Responses to Comments Regarding the First Semi-Annual 2007

Groundwater Monitoring Report at the Phoenix-Goodyear Airport South

(PGA South) Site, Goodyear, Arizona

# Responses to ADEQ Comments Dated October 11, 2007 Regarding the First Semi-Annual 2007 Groundwater Monitoring Report at the Phoenix-Goodyear Airport (PGA) South Site Dated August 7, 2007

# FIGURE 3

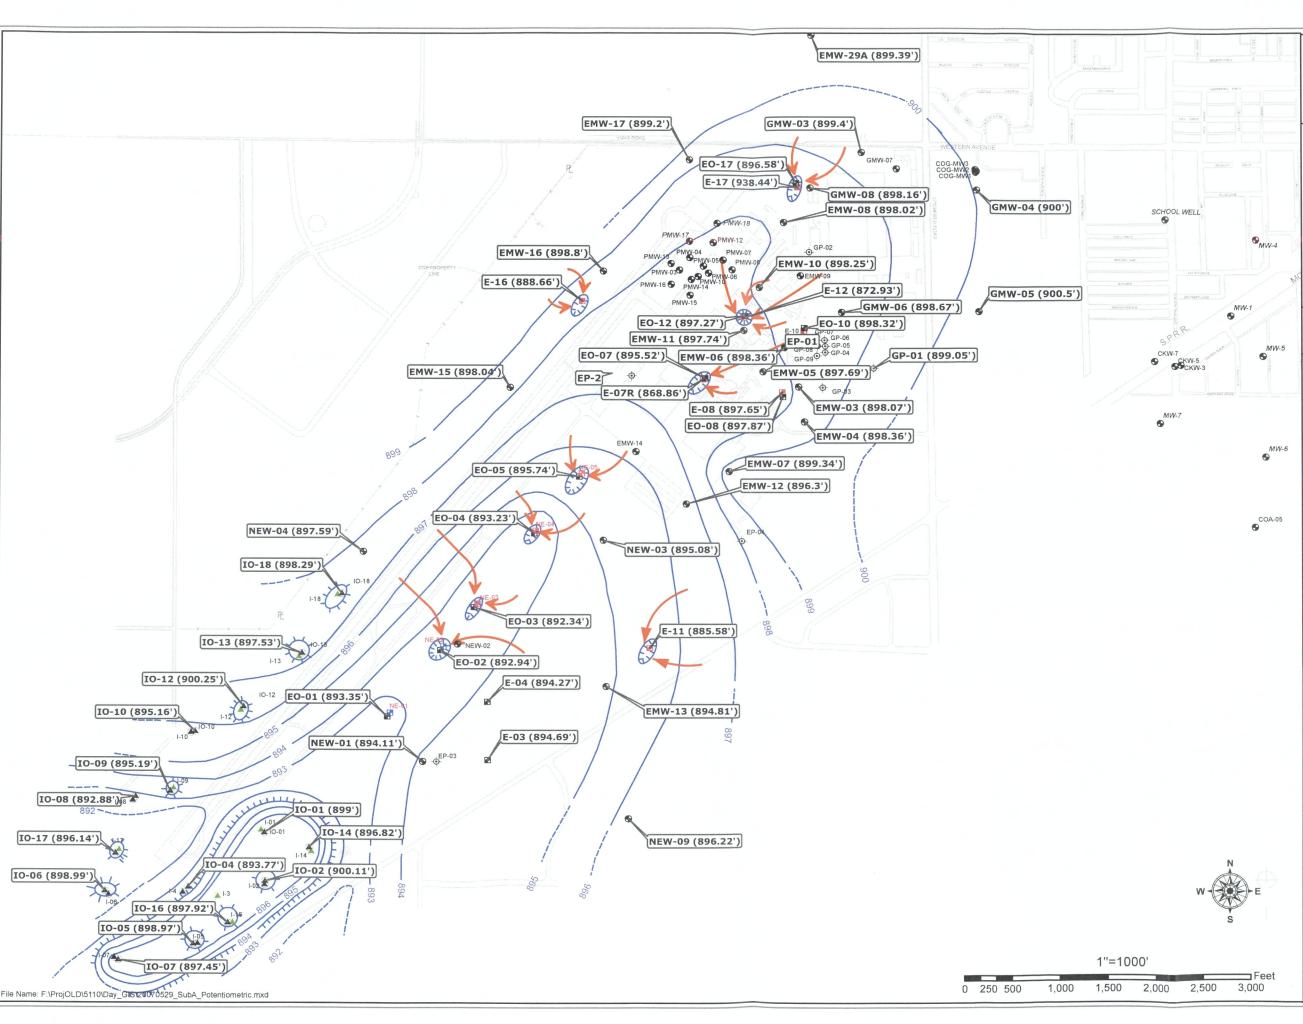
Figure 3 groundwater contours appear to be generally good except in the areas of the injection wells in the southwest portion of the map. It is suggested that this area may require additional attention.

Figure 3, **Potentiometric Map Subunit A** – The mounding effect at the southwest corner of the map is shown to be closed northwest, west, and south of Well IO-05. Well IO-07 shows similar high water elevation. Based upon this should this well be included in the mounded area, or at least the mounded area depicted by a dashed line in this area?

Figure 3, Potentiometric Map subunit A – Well IO-09 is shown with a water elevation of 895.19'; however the contours indicate only approximately 893.5' at this location.

The reviewer is correct in recognizing that the presentation and contouring of the Subunit A injection gallery can be improved. Please see the responses to Comments 6 & 7 for additional discussion.

Under the current operating system, not all of the Subunit A injection wells are individually metered. Whether an injection well is active or inactive is determined by visiting the well site. Most of the injection wells have meters that can be accessed to determine actual flow rates during the water level measurement period. This provides additional information to the professional preparing the contour maps.

LATA agrees that well IO-07 should be included in the mounding related to the southern Subunit A injection gallery. Similarly, mounding should be interpreted surrounding well IO-06 (elevation 898.99' asl) when compared to upgradient well IO-17 (elevation 896.14' asl). As presented in the response to General Comment 3, proposed updates and modifications to the individual injection wells of the injection gallery will greatly improve future representations.

Also, LATA would like to modify the explanation given in the Figure 3 Legend for those water level values that were highlighted in yellow. The caption in the Legend states "Suspect Water Level and Not Used in Interpretation". This is not correct. Those values that are highlighted in yellow correspond with Extraction well E-17, and Injection Observation Wells (IO-01,IO-06,IO-07 and IO-09. E-17 is an active pumping well, its water level measurement would not be used for contouring, but is not "suspect". The IO wells are associated with the southern injection gallery and have been previously discussed in the responses. The yellow highlighted IO water level measurements are "high" as would be expected, but are not "suspect". This confusion will be eliminated from future map presentations.

The reproduced Figure 3 Subunit A Potentiometric Map shows an injection mound surrounding well IO-09. This interpretation is warranted based on comparisons with water levels recorded in adjacent upgradient and downgradient wells.
